RE: Fire Area

2018 NCBC Chapter 2 Definition of Fire Area Related to Permanent Canopies

RE: REQUEST FOR FORMAL INTERPRETATION

Photo 1 - Noncombustible Drive Thru Canopy (Note: Canopy Not Attached to the Building)

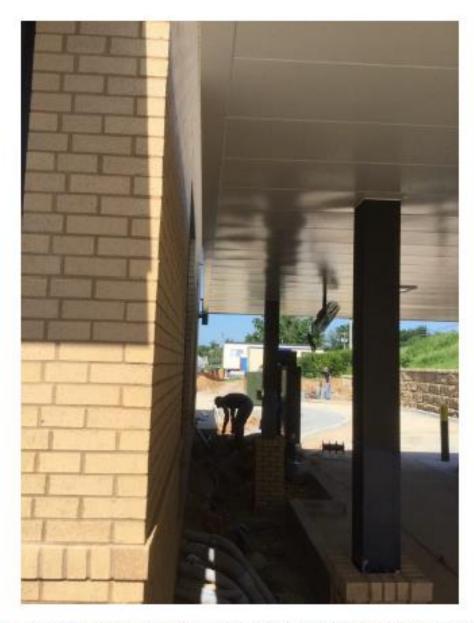
'Question #2: Do non-combustible awnings (like those shown in the attached photographs) add to the "Fire Area"?'

Question #2: Do non-combustible awnings (like those shown in the attached photographs) add to the "Fire Area?"

The photographs attached to the request for formal interpretation depict a canopy instead of an awning based on the definitions of "canopy" and awning" found in Chapter 2 because the structure is not "partially or wholly supported by the building". The conclusions of this letter are, therefore, based on a canopy instead of an awning.

Answer #2: Based on Section 101.3 I would conclude that the intent of the code is to provide protection to the occupants and building where a permanent canopy is capable of containing combustibles or occupiable space or both. Canopies, as shown in the photographs submitted with the request for formal interpretation, would be considered part of a fire area because it has a roof with potential fuel load.

Think of it this way; if the canopy was 30 feet away from the building it would be treated no different than any other building structure that has only a roof and no walls. That building would have a fire area.

The code, therefore, intends to protect the canopy depicted in the attached photographs as it would any other fire area. Without fire resistance rated occupancy separation between the enclosed building and the canopy as required by Section 508.4 the canopy is considered part of the fire area of the enclosed building.
